# BCA Capability Statement

Flower Power Redevelopment – Fruit & Pet Shop  
277 Mona Vale Road, Terry Hills

Flower Power  
C/- State Wide Project  
Management

09 May 2025  
Reference: S250182

Figure 1: Ground Floor Fire Separation

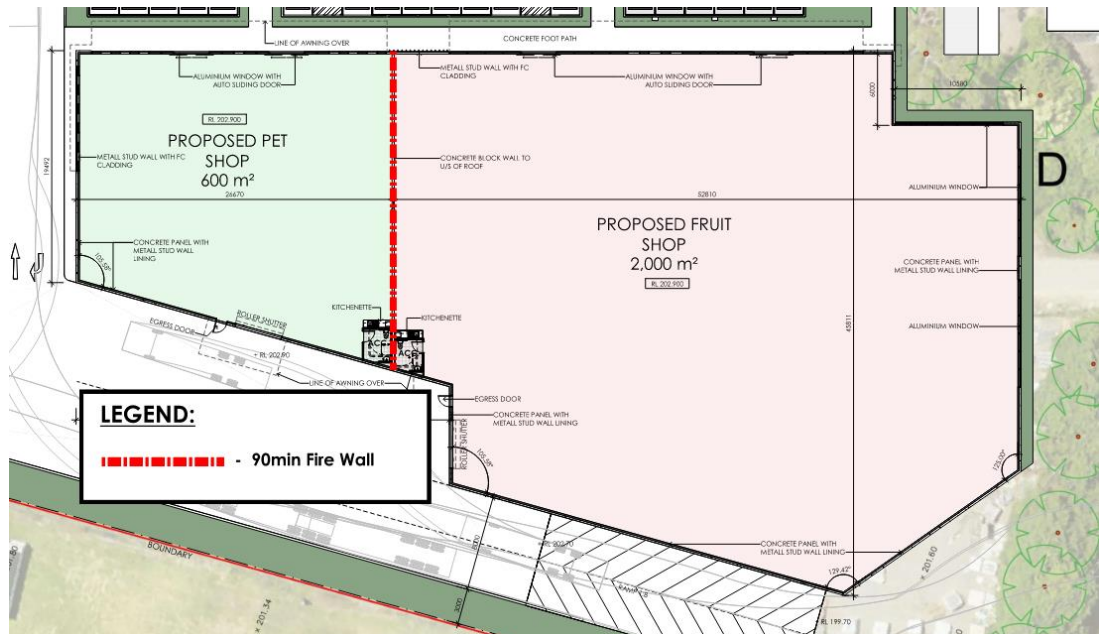
BM+G have been advised that a fire wall has been proposed as shown below. Accordingly, the building will not contain any fire compartments that exceed the limitations under clause C3D3.

A fire wall has been proposed to separate the two tenancies into fire compartments as to not exceed the fire compartment limitations requirements of C3D3.

- + 90/90/90 FRL fire separation between the proposed Pet Shop and Fruit Shop tenancies.
